Sunfield Fast-track

Auckland Council Specialist Memo

Annexure 7:
Auckland Transport
Neil Stone
4 August 2025

Figure 4 – Red - locations where road to road walkways should be provided. Yellow – locations where road to road access can be explored.

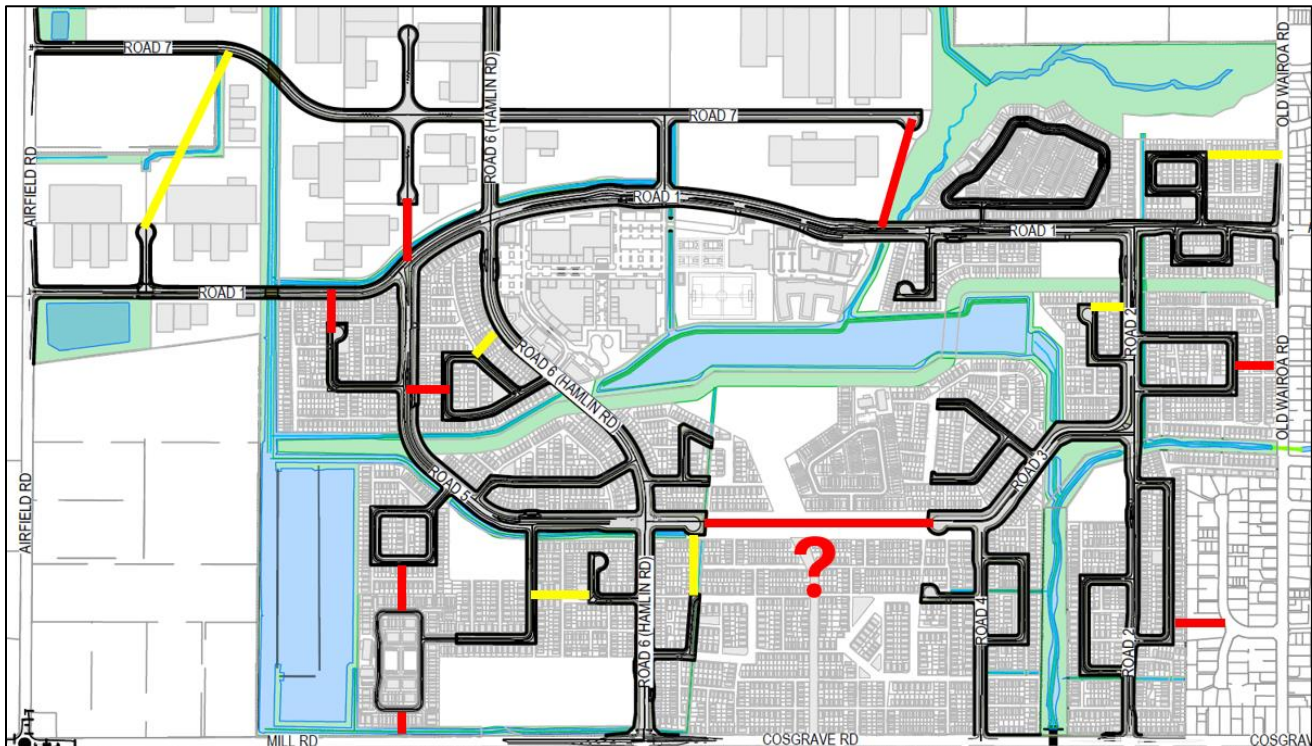
41. Road to road vested active modes connections internal to the site do not seem to be provided. The application drawings seem to indicate certain locations where these are possible, but these are not labelled. Figure 4 below shows in red the locations where it is considered that vested road to road accessways should be provided as part of the road network. This is considered a requirement of any large subdivision application^{9 10}, especially since the proposal has significantly reduced reliance on general vehicle travel. The proposal, as presented, does not indicate an efficiently connected neighbourhood, rather isolated residential blocks that do not allow for a connected and efficient layout of street patterns (legally).

42. In this regard 8m wide road to road accessways (as per AT's design standards) is recommended. The recommended road to road accessway locations are provided in the red lines on Figure 4 below. The connections offer significantly reduced travel time around the neighbourhood and key destinations. The yellow lines in Figure 4 below indicate where these connections could be beneficial, where the applicant can investigate providing a connection through an accessway or easement.

Figure 5 – frontage upgrades proposed in red, with yellow indicating AT's required upgrades areas.

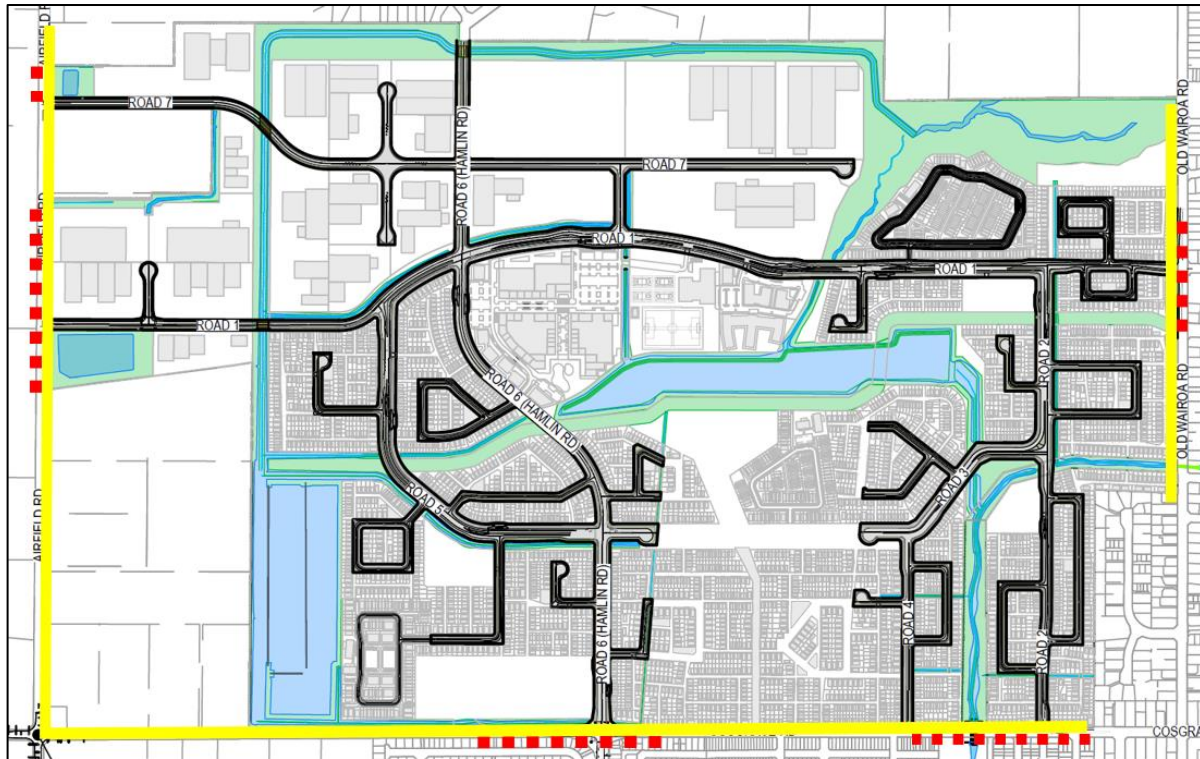
47. It is unclear to what extent the applicant proposes to upgrade the site's frontage in terms of active mode upgrades. The applicant plans show limited sections of frontage upgrades – generally where the red dashed lines are presented in Figure 5 below. However, with the site not being earmarked for development, it is required that this site provide upgrades along the entire site 'block' to connect the site to the surrounding network, as this is required but unlikely to be provided by any other parties.

- Shared path on Airfield Road (3m wide minimum)
 - Separated cycling and walking facilities or shared path on Mill Road and Cosgrave Road.
 - Separated cycling and walking facilities on Old Wairoa Road is preferred and will need to link in with the proposed path on Okawa Avenue and the existing on-street cycleway in Old Wairoa Road north of PA karaka Drive.

Figure 6 – applicant's suggested upgrades

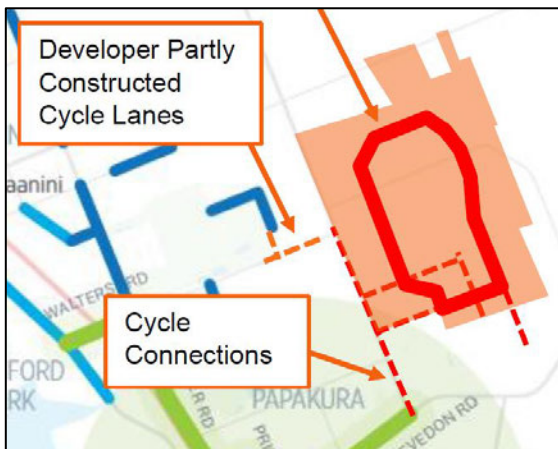
49. With regard to connecting the site to the wider road network from an active modes perspective, as mentioned above, the statement that the proposal attempts to align with AT's cycling strategy for the area is considered less relevant. Transport strategies for this area does not take into account that this (unanticipated) development will occur. Figure 6 below (Commute transport assessment figure 7-2) shows the proposed active modes links (dark orange dashed lines) provided by the applicant. In this regard, AT considers the following:

Figure 7 – AT recommended additional active modes upgrades

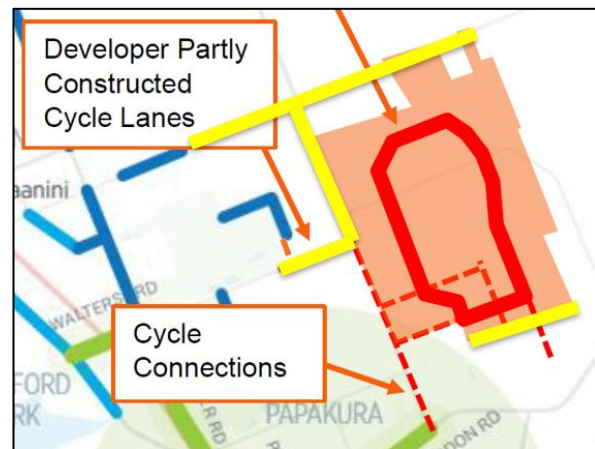
- e) The recommended upgrades also include active modes facilities on Mill Road, between Airfield Road and Walters Road.

f) The upgrades as per items d. and e. above are illustrated in yellow in Figure 7 below.

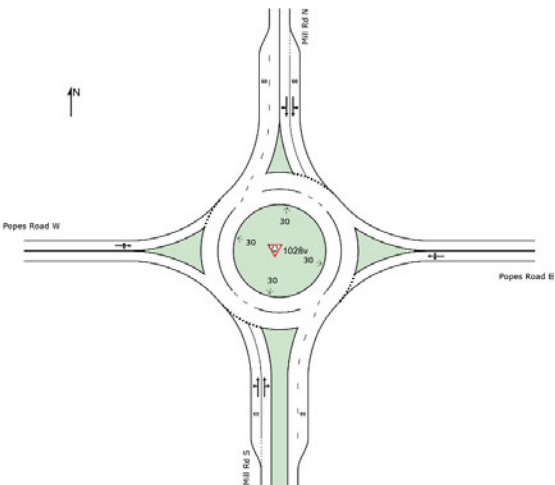
ITA layout	Beca Tested Layout
Airfield Road / Mill Road  We tested with the ITA layout which was giving delay of 299s(AM) and 311s(PM).	Airfield Road/ Mill Road  Comments : Additional lanes included along Airfield Road on both sides to accommodate the increased traffic flows on the Airfield Rd. Note this arrangement still has a poor LOS and will need further mitigation. There is also a risk of additional land being required for the intersection footprint.

Popes Road/ Mill Road

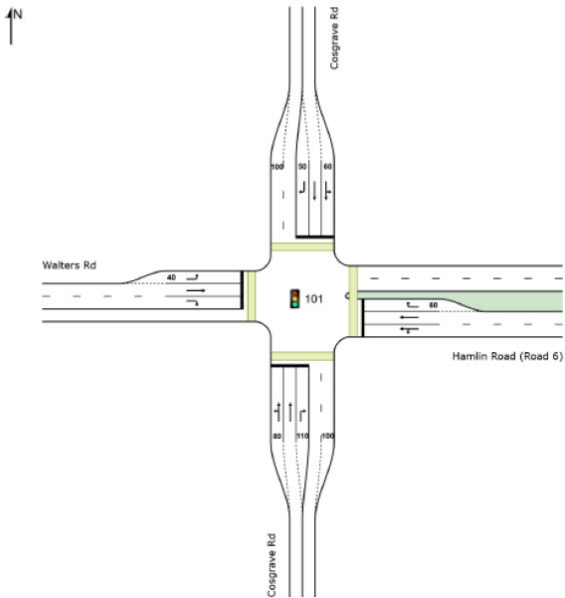
Comments : The roundabout has also been tested with a single lane along Mill Road but fails to accommodate the estimated 2041 volumes. Hence dual lanes for the roundabout have been considered with two lanes on the Mill Road. The 20 m roundabout diameter would deteriorate the LOS from B (current LOS for 30m diameter) to E. Note this may require land outside the current road reserve.

Cosgrave Road/ Walters Road/
Hamlin Road

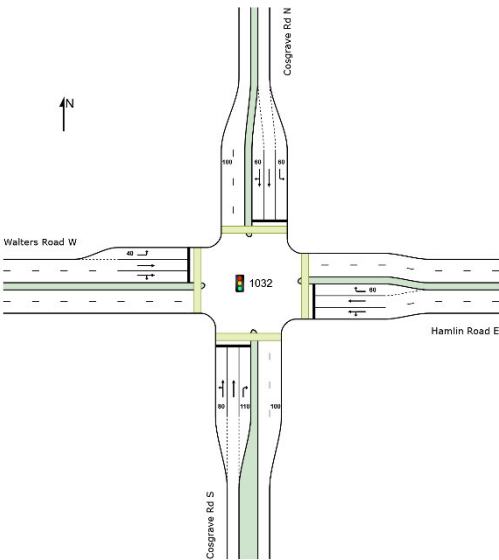
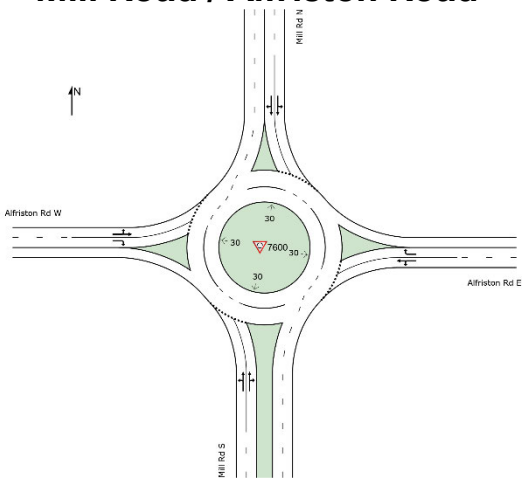
Comments : The lane arrangement has been altered along the North Arm and West Arm to accommodate the predicted volumes.

Mill Road / Alfriston Road

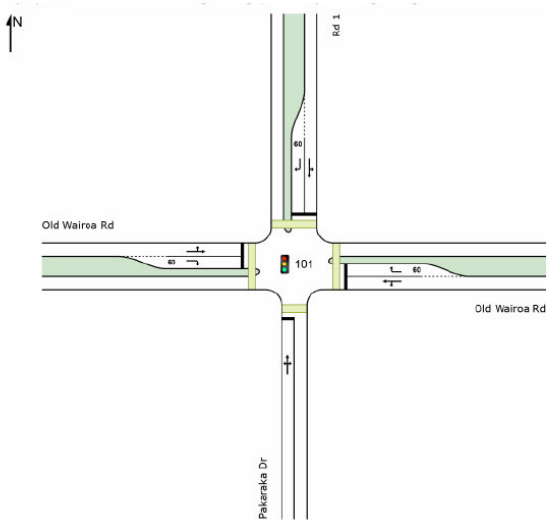
Comments : A dual lane roundabout have been considered for the analysis. The intersection fails in single lane configuration. Note this may require land outside the existing road reserve.

Pakaraka Drive / Old Wairoa Road / Road 1

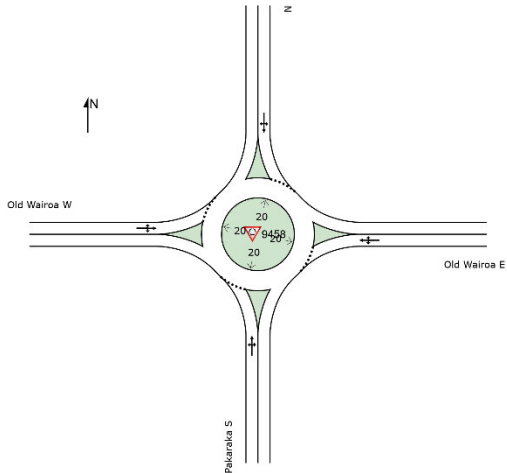
Comments : The ITA layout gives an LOS of F but performs with an acceptable LOS as a single lane roundabout. Ped/cycle crossings would need to be considered seperatley.

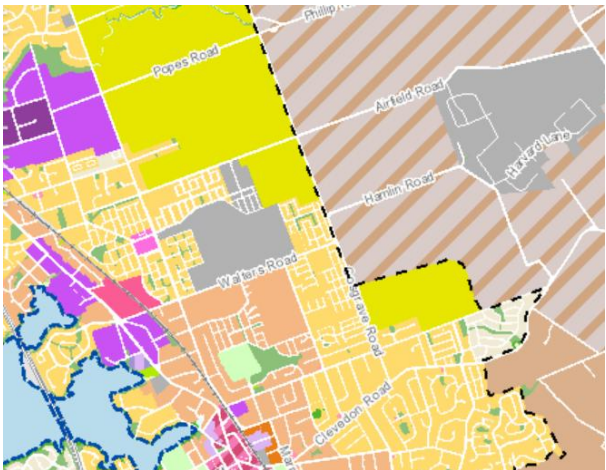
This will not achieve the vision as the necessary connections are not made. The proposed shared paths are also not suitable for the level of external commuter cycling anticipated (over 200 external cycle trips in the peak hour), which requires fully separated facilities.

The proposed network also does not recognise future growth in this area, for example the area shown in yellow as future urban zone below. There is a large area of future urban to the North of Airfield Road. Access to the Sunfiled site (employment zone for example) for these residents would be via Airfield Road which is currently devoid of walking and cycling facilities. An upgrade to Airfield Road is also warranted as part of this development to provide suitable access to/from surrounding areas including that not yet developed.

The development should provide separated cycle facilities along the length of Mill Road / Cosgrave Road between the northern extent of the development site and Old Wairoa Road, along the Old Wairoa Road frontage, and the Airfield Road frontage.

Figure 1 - Example of long pedestrian routes to access bus stops

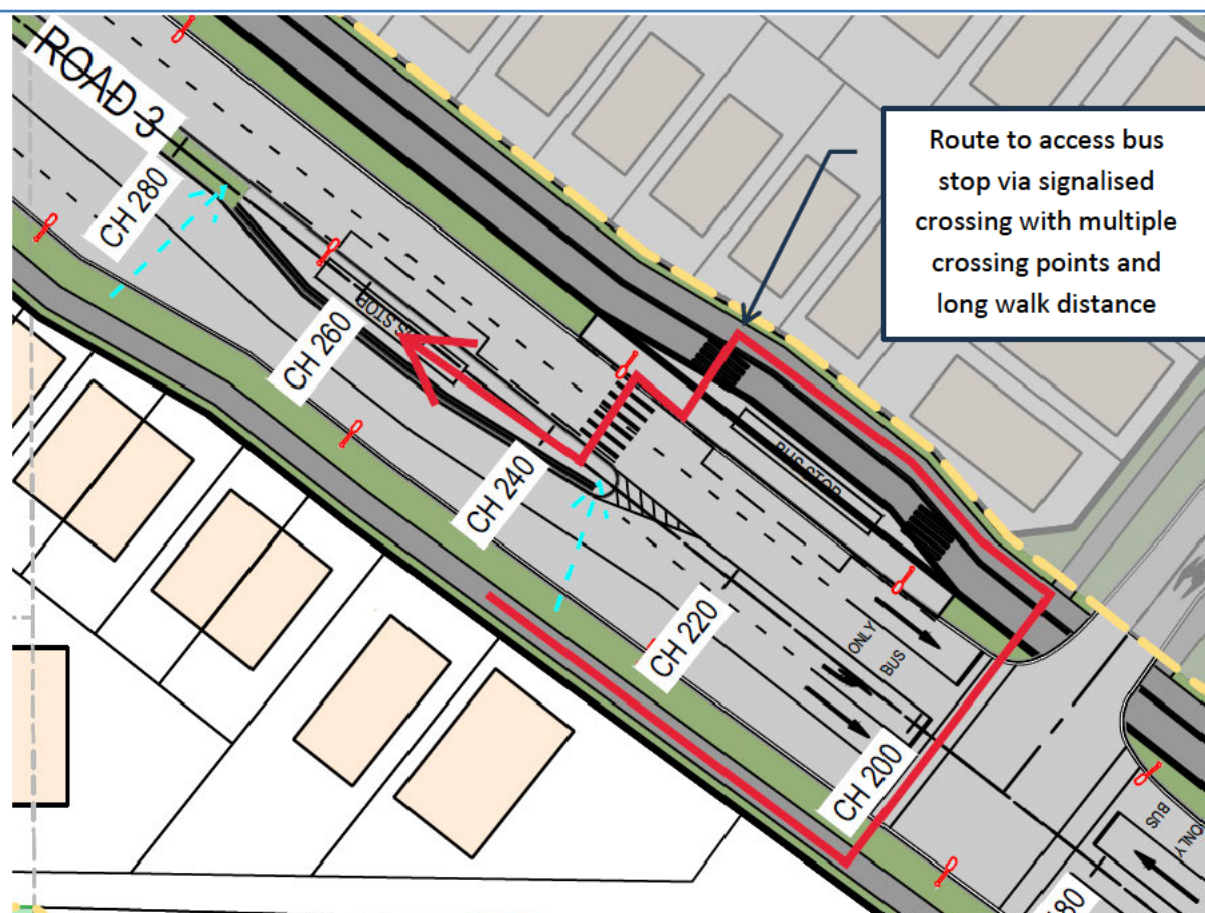
The bus stops have been designed in pairs and have pedestrian crossings (zebras) provided across the busway. This will provide access to the bus stops for pedestrians on the side of the road with the separated cycle path and footpath. However, for pedestrians on the opposite side of the road, in many cases the only facilities for pedestrians to access the bus stops is via neighbouring signalised intersections (refer to Figure 1 for an example). This would significantly increase the travel distance, travel time, and the number of times pedestrians would need to cross the road. This is likely to either be a deterrent for pedestrians to use the buses or to result in pedestrians crossing away from the signalised crossings. This will increase the risk of potential conflicts between pedestrians and vehicles. Consideration should be given to providing more direct and convenient crossing points to reach the bus stops from the side of the road opposite the bus way.

Figure 2 – Example Intersection of Issues Highlighted

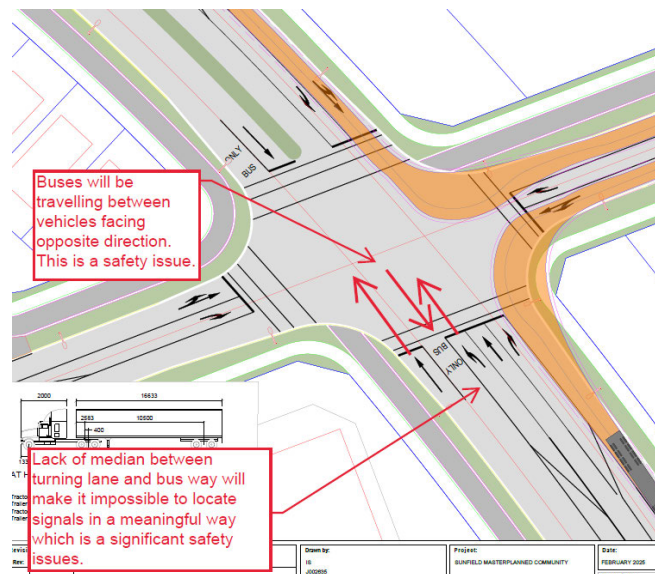
Many of the signalised intersections with the bus way remove the median island between the general traffic lanes and the bus way (refer to Figure 2 of an example intersection).

The median has been removed to form a left turn lane. This lane is required as the left turn movement needs to be held on a red signal whilst the through movements along the bus way and the general traffic lanes run on a green signal. However the removal of the median island will result in:
